825 NORTH BROADWAY WHITE PLAINS, NY 10603 (TOWN OF NORTH CASTLE)

AUTOMOBILE SERVICE STATION ALTERATION (GAS TANKS REPAIR AND CONVENIENCE STORE INTERIOR ALTERATIONS)

We have revised the plans to answer the May 20, 2022 comments from the Town Consulting Engineering John Kellard, P.E. as follows (**in bold**):

EROSION CONTROL PLAN

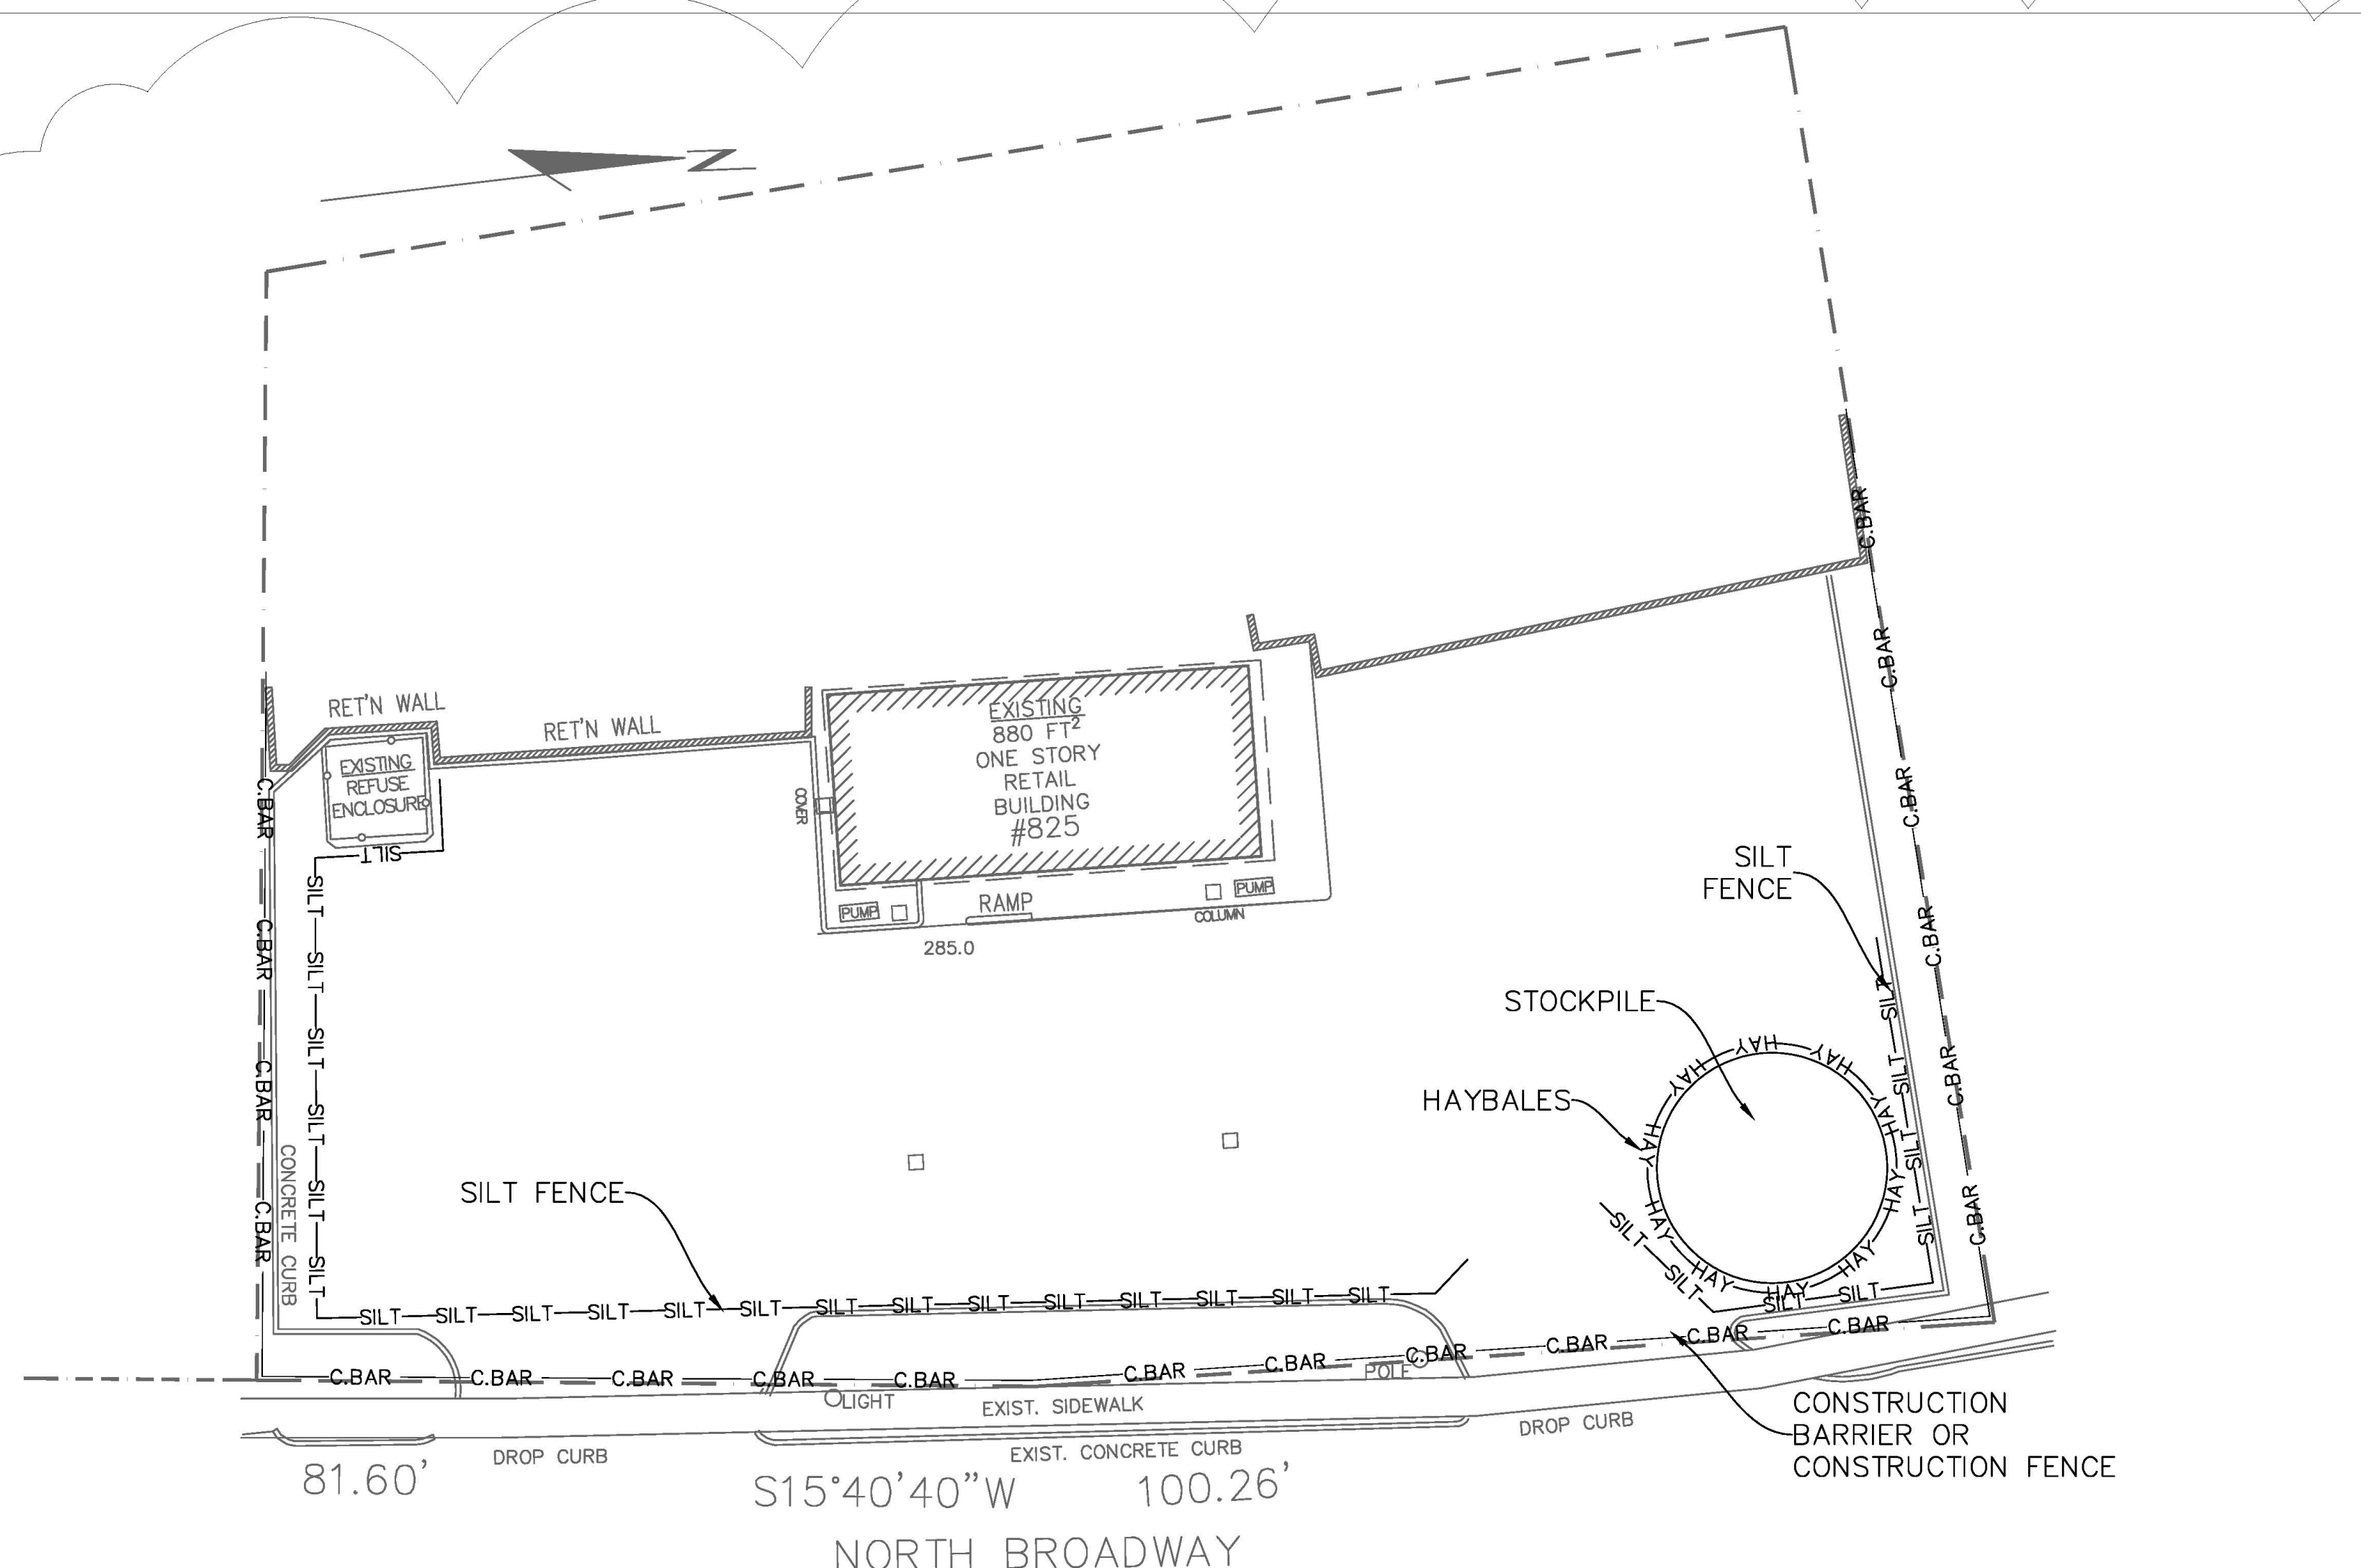
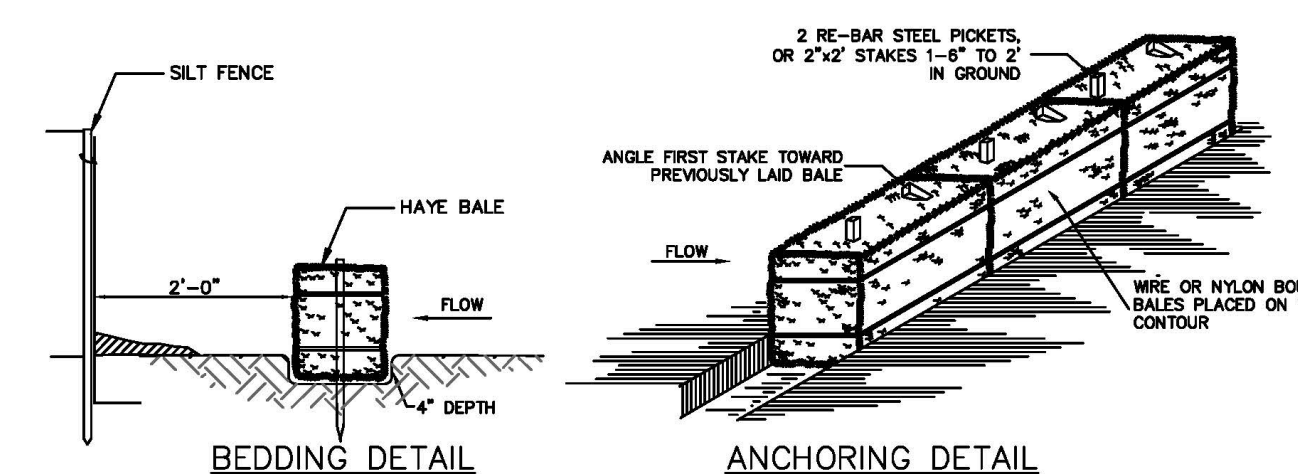
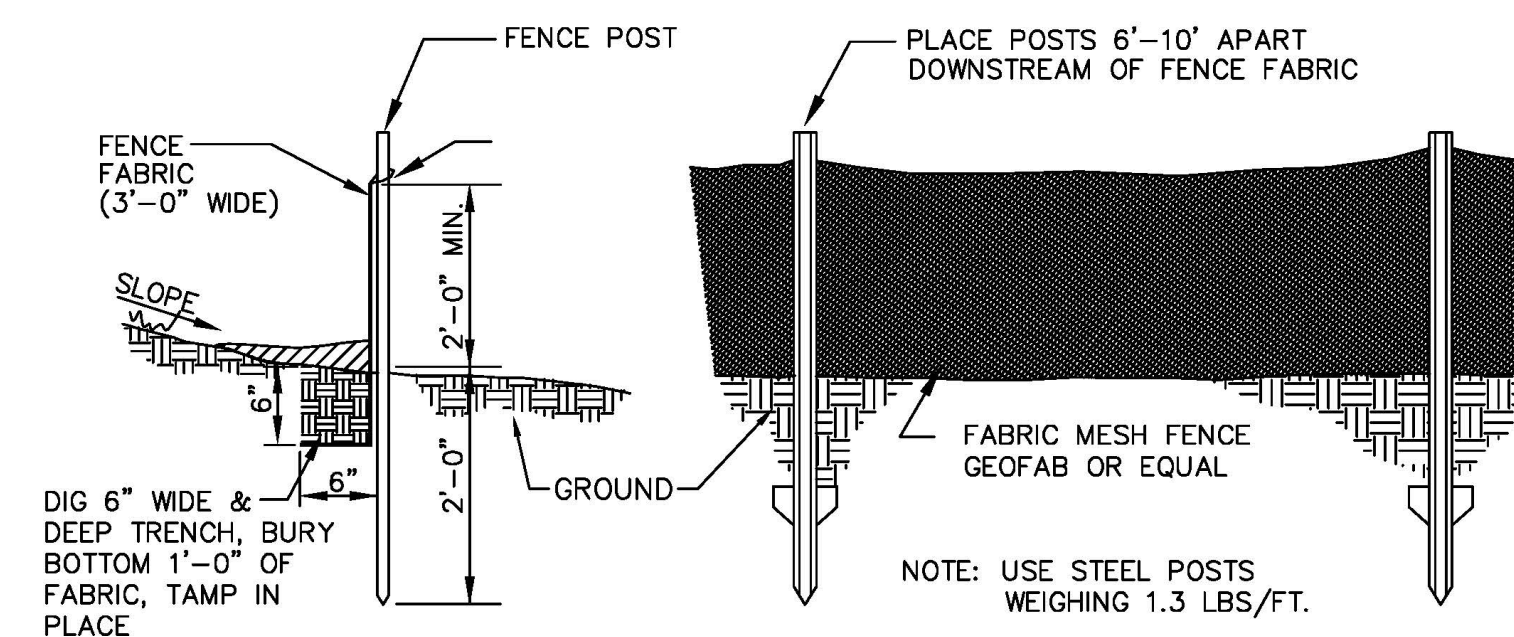
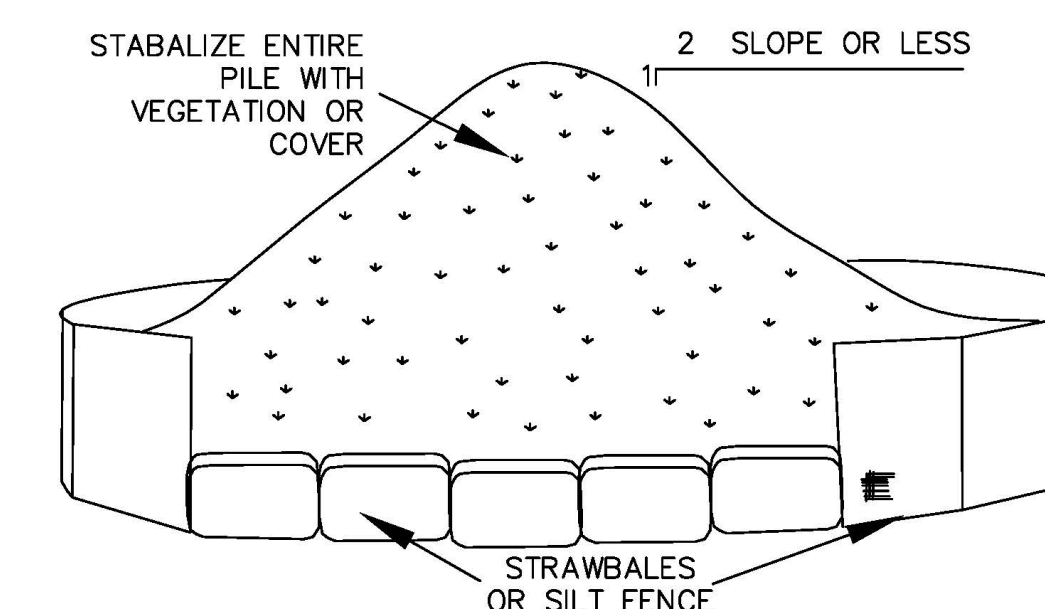
7. Please provide an erosion and sediment control plan with details.

New page C1 added with erosion control details.

DRAWING TITLE:
 NYSDOT
 STANDARD
 DETAILS

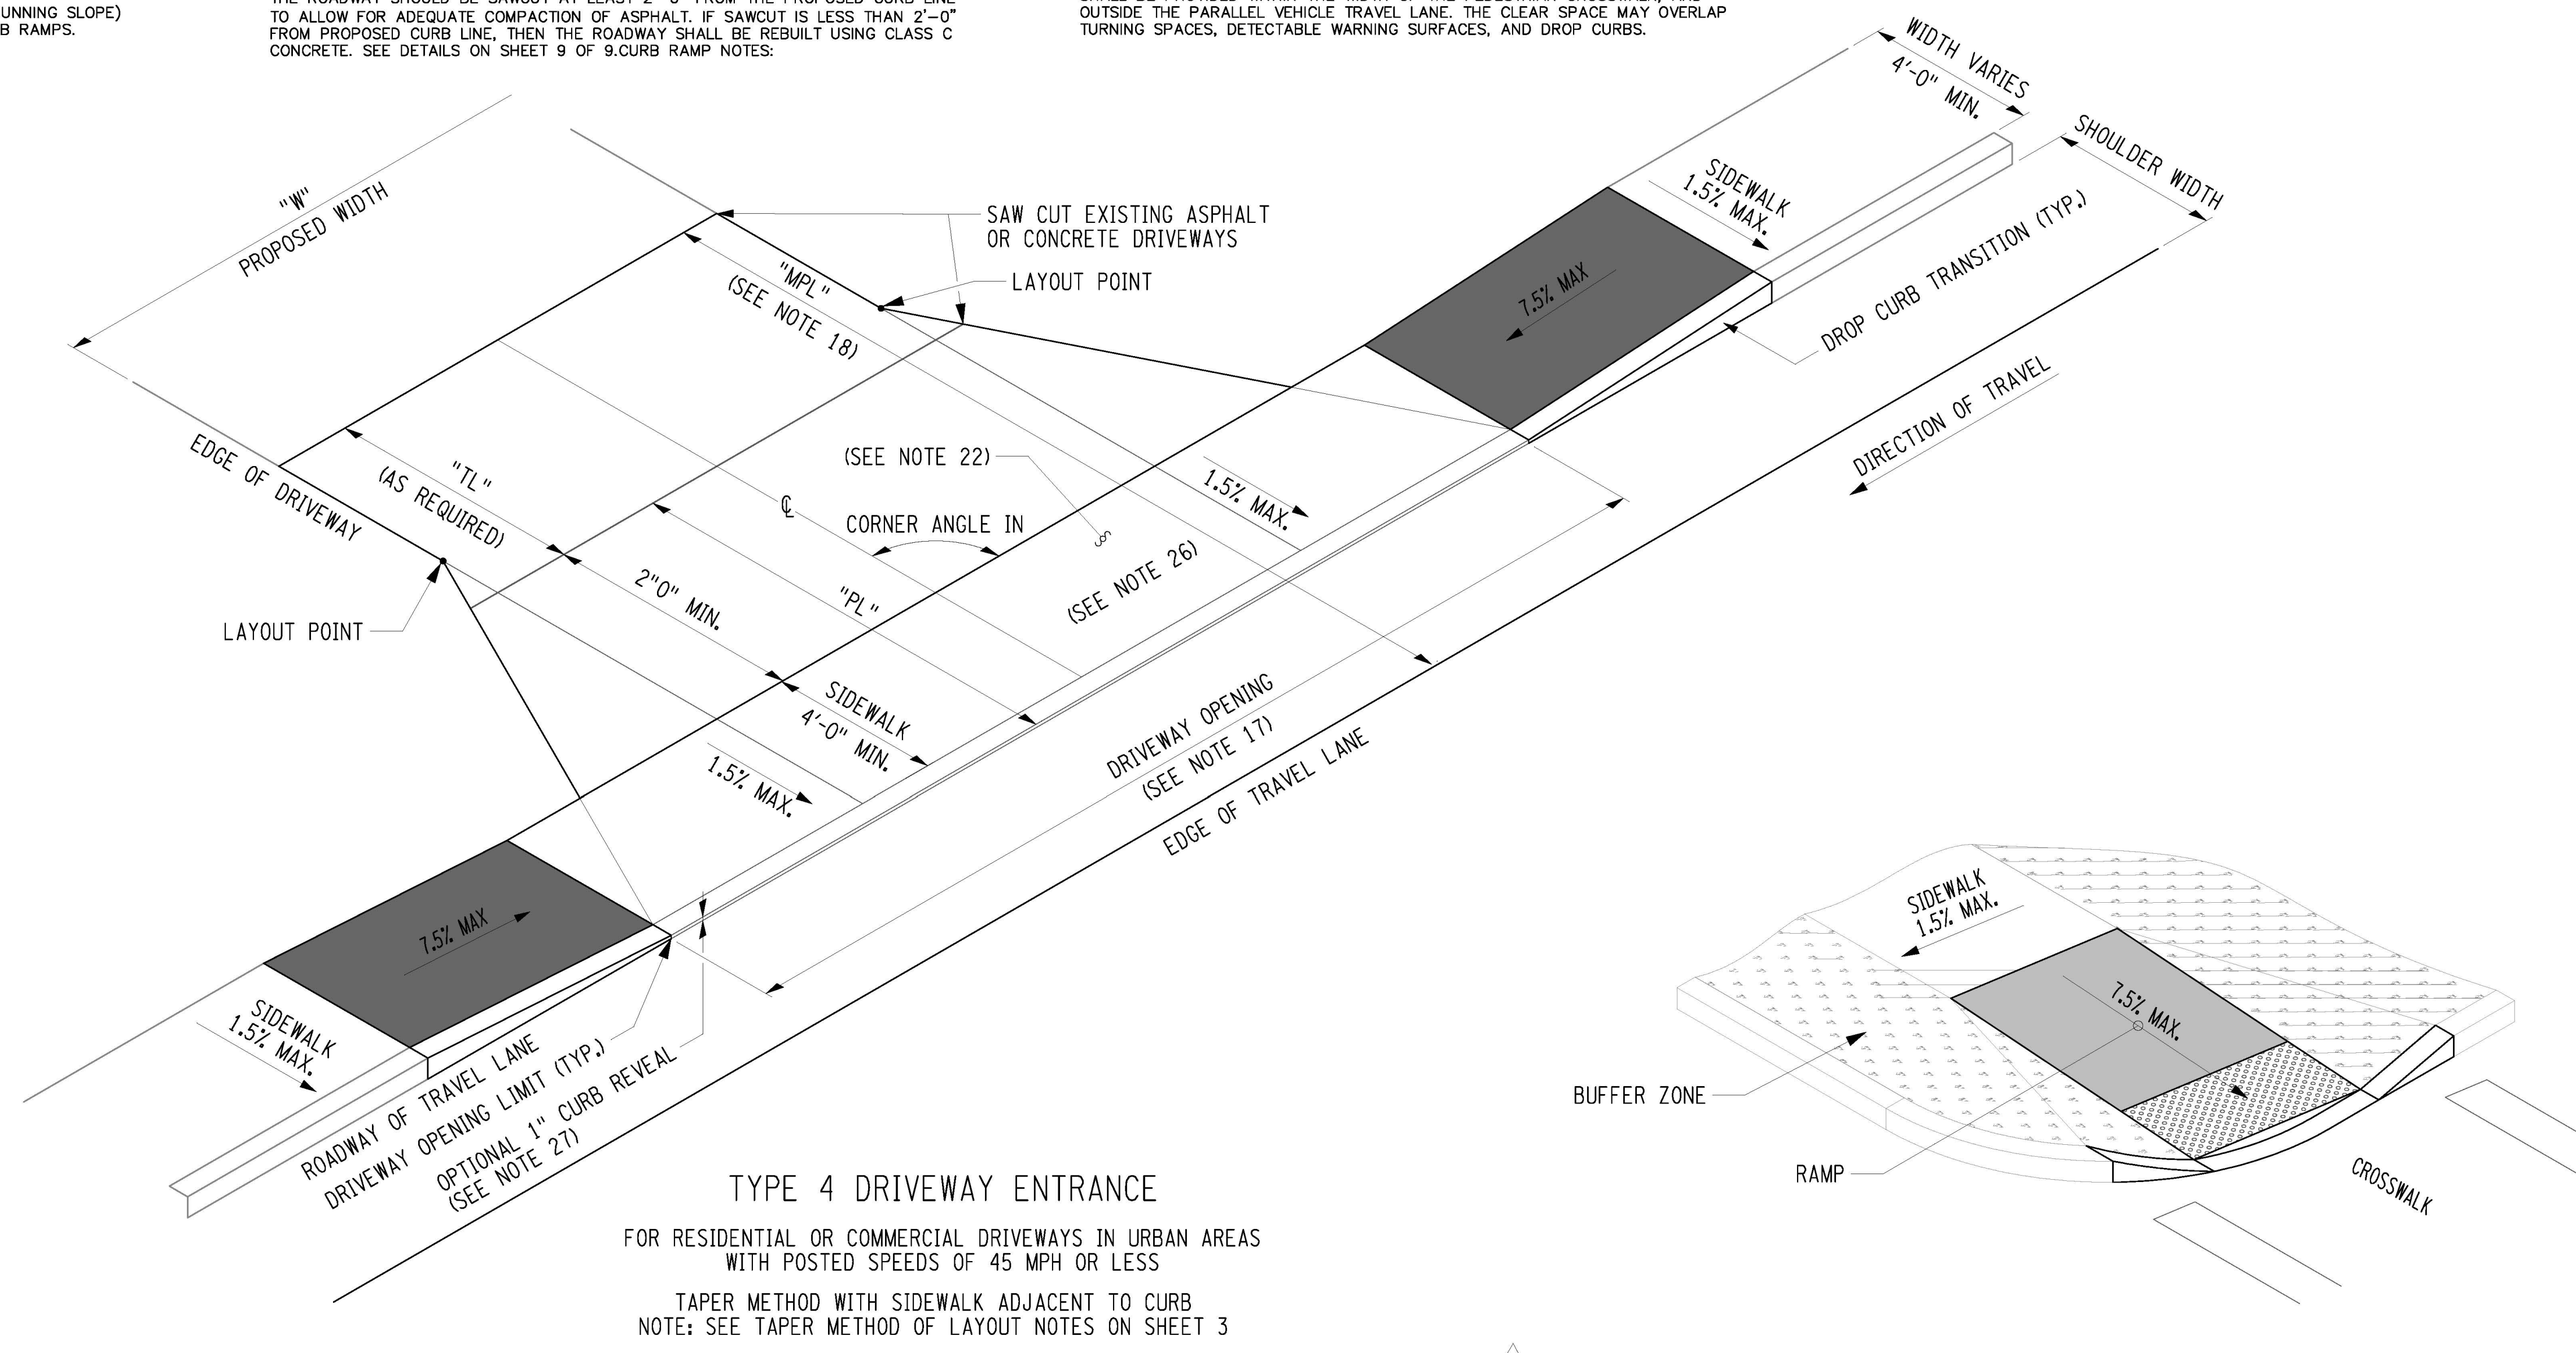
3. The sidewalk repairs within the New York State right-of-way should be further detailed, specific to exactly which portions of the walk and curbing will be replaced, as well as the improvements proposed across the curb cuts. Please provide sidewalk curbing and handicap ramp details. Work within New York State right-of-way will require a New York State Department of Transportation (NYSDOT) Highway Work Permit.

New page C2 with NYSDOT sidewalk notes and details added.
